Gilchrist/Crescent Public Workshop  
 Gilchrist Restaurant Banquet Room  
 Meeting Notes  
 October 11, 2007

**Options for sidewalks in Crescent** (see diagrams at end of notes)

<b>OREGON DEPARTMENT OF TRANSPORTATION</b>	
<b>kptf</b> Consulting Engineers <small>2000 NE Oregon Street, Suite 200        Corvallis, Oregon 97331        Phone: 541-325-1111 Fax: 541-325-1112</small>	
<b>US97: OR31 HWY JCT - SCL CRESCENT</b> THE DALLES-CALIFORNIA DESCHUTES & KLAMATH COUNTIES	
Design Team Leader - T. SHELL Designed By - F. MADDOX / M. BEYER Drafted By - B. CADOU	
<b>TYPICAL SECTIONS</b> <b>MP 185.10 TO 186.85</b>	SHEET NO. <b>1</b>

#### Poor Pavement north of Gilchrist and south of the bridge

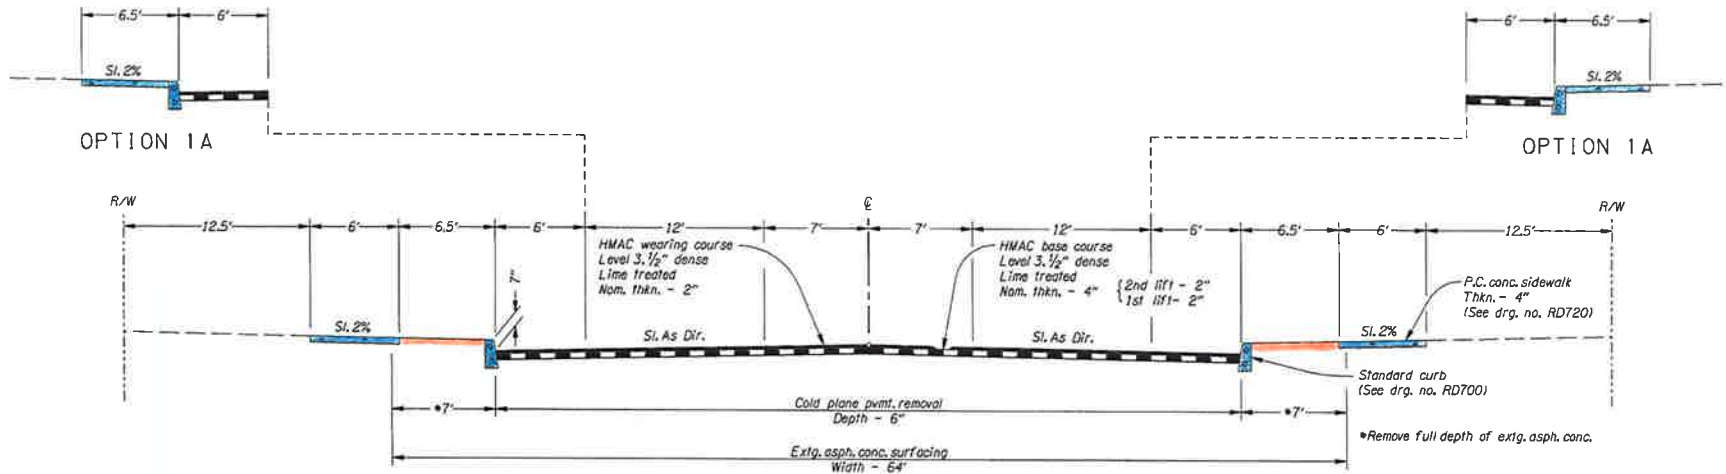
- This section of pavement is constantly falling apart and needing repair. Can a French drain system be installed to take care of the water issue? ODOT has noted this problem and is working on a solution.

OPTION 1

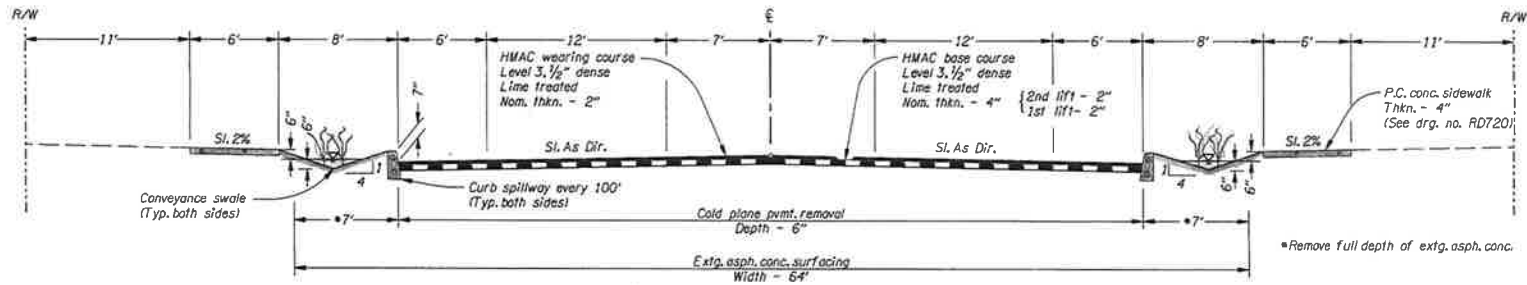
Pros	Cons
Option 1	Doesn't change area in front of businesses (perceived right of way)	Have to rebuild storm water system
		Maintenance of the 6.5 foot open space – not landscaped
		Not visually appealing
		Snow removal from the highway could run onto the sidewalk.
Option 2	Sidewalk is separated from the highway	Area in front of businesses/residences is smallest with this option but doesn't require right of way.
	Do not have to rebuild storm water system	
	Visually appealing	
Option 3	More separation of the sidewalk and highway than option 2	Area in front of businesses/residences is smallest with this option but doesn't require right of way.
	Flat bottom ditch is easier to maintain than option 2 (v ditch)	
	Flat bottom ditch has the ability to hold more water than option 2 (v ditch)	
	Do not have to rebuild the storm water system	
	Visually appealing

**Option 1:** This option was *dismissed* based on the comments listed in the table.

OPTION 2

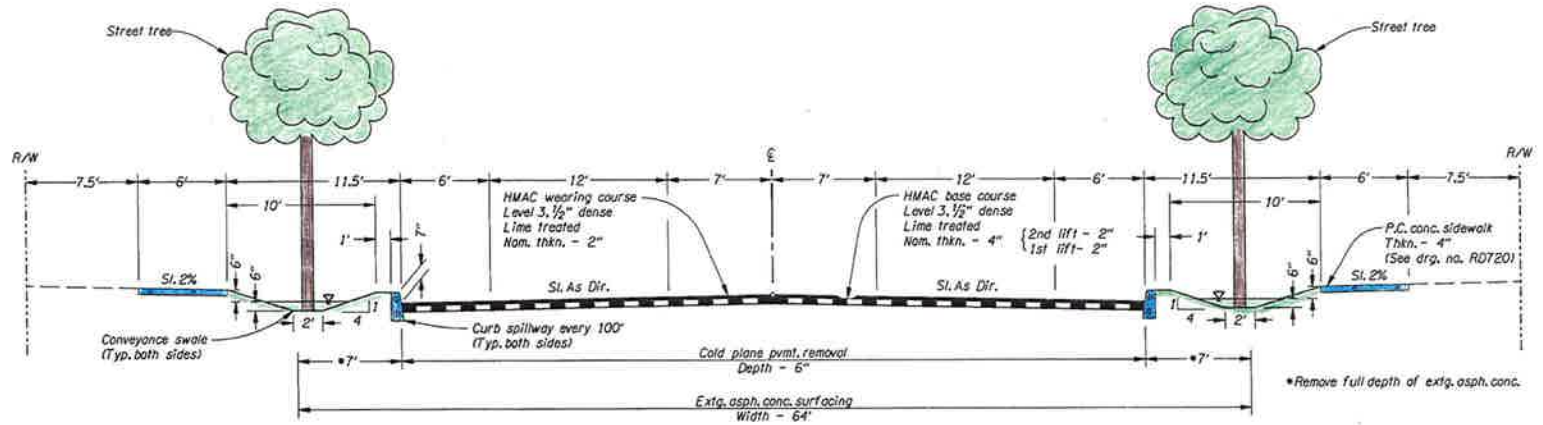
**Option 2:** This option was *dismissed* because the landscaped ditch in Option 3 provided more water retention and easier maintenance.
